No. PSE&TD/ CEA/405-F/2016/86-A

**Sub: Minutes of the meeting of the Standing Committee of Experts held on 8/12/2015 at CEA Headquarter regarding failure of towers in 132 kV and above voltage level transmission lines of PGCIL/ RRVPNL/ UPPTCL/ WBSETCL/ JINDAL POWER LTD. in the Western/ Eastern/ Northern region during October 2014 to June 2015 including failure of 765 kV S/C Gaya- Fatehpur Trans line in May, 2014.**

**Minutes of Meeting of the Standing Committee of Experts on Failure of Transmission Line Towers held in CEA, New Delhi on 8/12/2015 in respect of failure of towers in 132 kV & Higher Voltage Transmission Lines during the period from October, 2014 to June, 2015.**

SCALE	N.T.S	DRG. NO.	SHEET NO.
DESIGN	gwwjz	C.ENG:TL	1/2
CHECKED		REV. SYL.

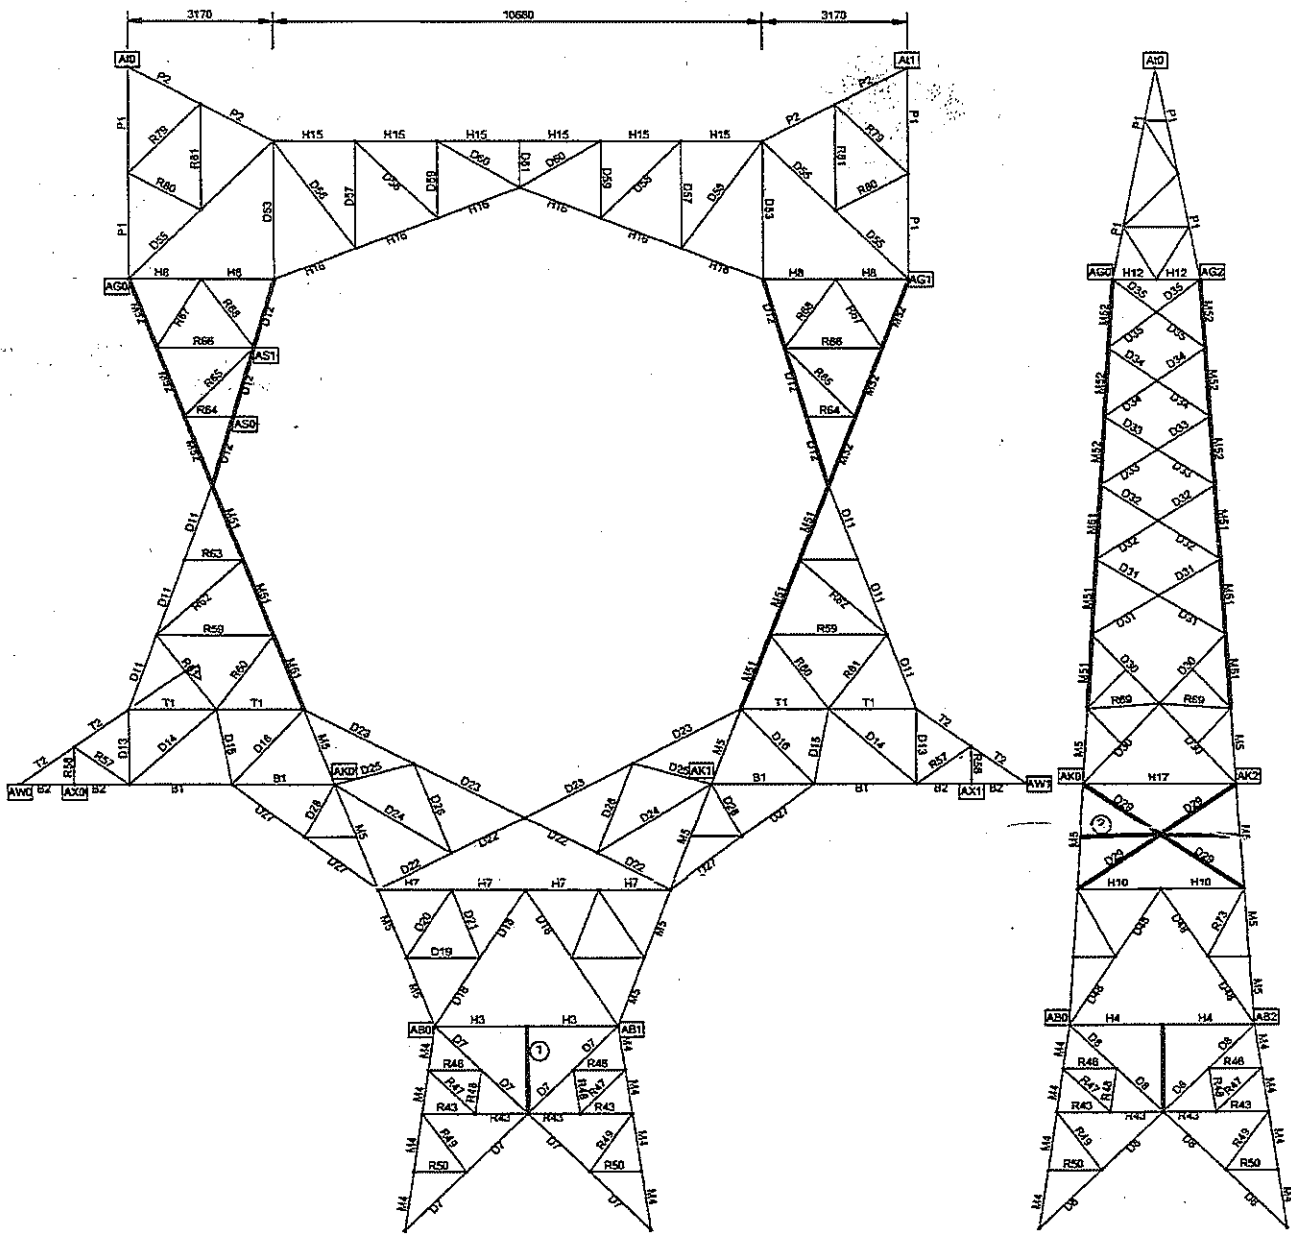
- (e) PGCIL has agreed to revise the design of the 765kV Tower Type-A used in Gaya - Fatehpur line by strengthening the Tower [increasing the member / section size of six (6) members including three (3) members / sections as suggested by CPRI and adding two (2) more redundant members].

- In absence of meteorological data, it has become difficult to assess the actual wind velocity at site of failure in order to verify with the design value of wind speed. However, the detailed analysis of structural design of suspension tower (with delta configuration) of 765kV S/C line was carried out by CPRI and PGCIL using two different softwares [STAAD Pro and i-Tower]. The strengthening of suspension towers (with delta configuration) of 765kV S/C line traversing through wind Zone - 4 has to be carried out as indicated below by increasing the member / section size of six (6) members and adding two (2) more redundant members. The drawing showing the member location is enclosed as **Annexure - II**.

Member No.	Original Member size	Proposed Member size	Existing No. of Bolts	Proposed No. of Bolts
D13	65x65x5 (MS)	65x65x6 (MS)	2 SS - 16Ø	2 SS - 16Ø
D16	80x80x6 (MS)	90x90x6 (MS)	2 SS - 16Ø	2 SS - 16Ø
D29	70x70x5 (MS)	90x90x6 (MS)	2 SS - 16Ø	3 SS - 16Ø
M51/52	100x100x8 (HT)	110x110x8(HT)	6 DS - 16Ø	6 DS - 16Ø
D12	75x75x6 (HT)	80x80x6 (HT)	3 SS - 16Ø	3 SS - 16Ø
New Redundant connected to M5	-	50x50x5 (MS)	-	1 SS - 16Ø
New Redundant connected to H3/H4	-	50x50x5 (MS)	-	1 SS - 16Ø

Rev: 1  
 Typographical error in grade of M51/52, R12 correct grade is HT. 2mm
